Adopted solutions on production:**Step 1 – Temporary solution**

**Step 2 – Final solution**

reinforcement pipe
p/n 137869111/0

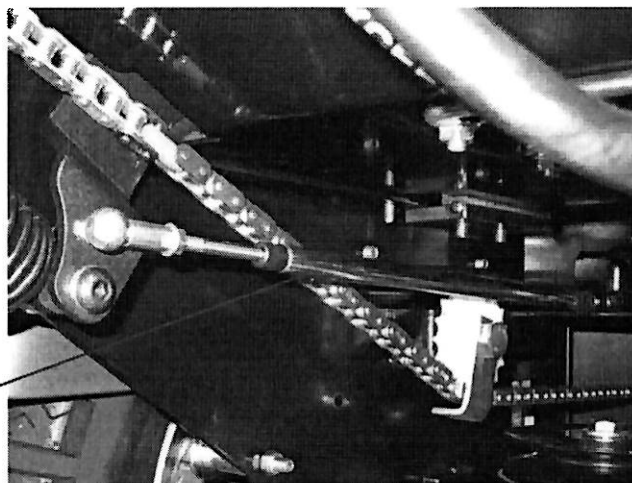
A temporary solution was adopted on machines produced from end of June 2015 from serial number 150617047Z by adding the metal pipe p/n 137869111/0 working as cable reinforcement. This solution was previously announced with Service Bulletin FM-039 and has been replaced by the final solution described on step 2.

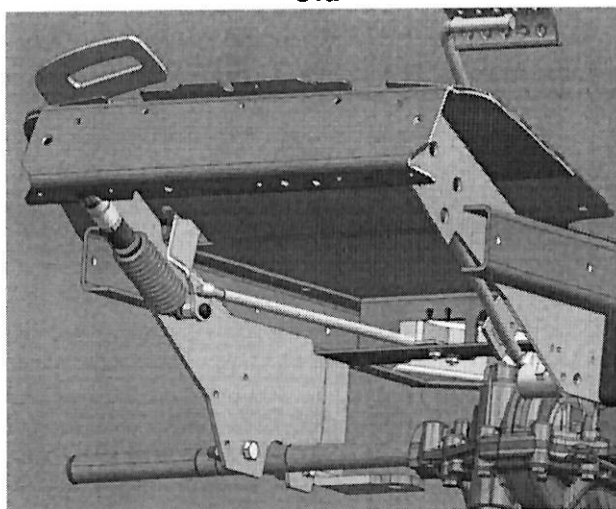
As final solution, the machines produced from November 2016 with serial number higher than 161102011Z have a new speed cable p/n 187000210/0 with a mounting system preventing the rigid end of the cable from bending.

The new solution does not require anymore the use of the reinforcement pipe p/n 137869111/0. Below drawings show the difference between old and new solution.
